Access Compliance Report

Public Rights-of-Way

(Curb Ramps)

Intersection ID: 15402	Main Street: MARSH_RD	Cross Street: NEW_BERN_ST	Location:	N
ADA ID: 9F8C5C648571	Ramp Type: Perp	Initial Pass/Fail: Fail	Overall Compliance: No	Severity Score: 12.5
Codes/Mitigation Info/Possible Solution		Field Measurements/Component Compliance

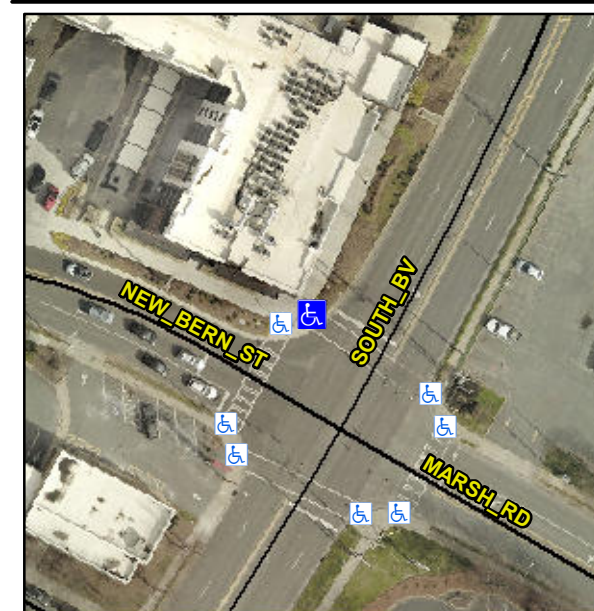
Not Found, R304.2.2

Compliance	Description	Data	Compliance	Description	Data
N/A	Ramp Length (in)	24.0	No	Ramp Slope (%)	9.4
Yes	Ramp Width (in)	48.0	Yes	Ramp XSlope (%)	1.0
N/A	Flare Type LT	N/A	N/A	Flare Type RT	N/A
N/A	Flare Slope LT (%)	N/A	N/A	Flare Slope RT (%)	N/A
N/A	Flare Traversable LT?	N/A	N/A	Flare Traversable RT?	N/A
N/A	Landing Length (in)	N/A	N/A	DWS Provided?	N/A
N/A	Landing Width (in)	N/A	N/A	DWS Contrast?	N/A
N/A	Landing Slope (%)	N/A	N/A	DWS Length (in)	N/A
N/A	Landing X Slope (%)	N/A	N/A	DWS Full Width?	N/A
N/A	Landing Curb? (Y/N)	N/A	N/A	DWS Offset (in)	N/A
N/A	Shared Landing?	N/A			
N/A	Gutter Ponding?	N/A	N/A	Gutter Slope (%)	N/A
N/A	Gutter Lip Ht (in)	N/A	N/A	Gutter X Slope (%)	N/A
N/A	Painted X Walk1?	Yes	N/A	Painted X Walk2?	N/A
	X Walk 1 Direction	To SE		X Walk 2 Direction	N/A
N/A	X Walk 1 Width (in)	110.0	N/A	X Walk 2 Width (in)	N/A
	X Walk 1 Slope (%)	1.1		X Walk 2 Slope (%)	N/A
	X Walk 1 X Slope (%)	1.0		X Walk 2 X Slope (%)	N/A

Remove & Replace Entire Ramp.
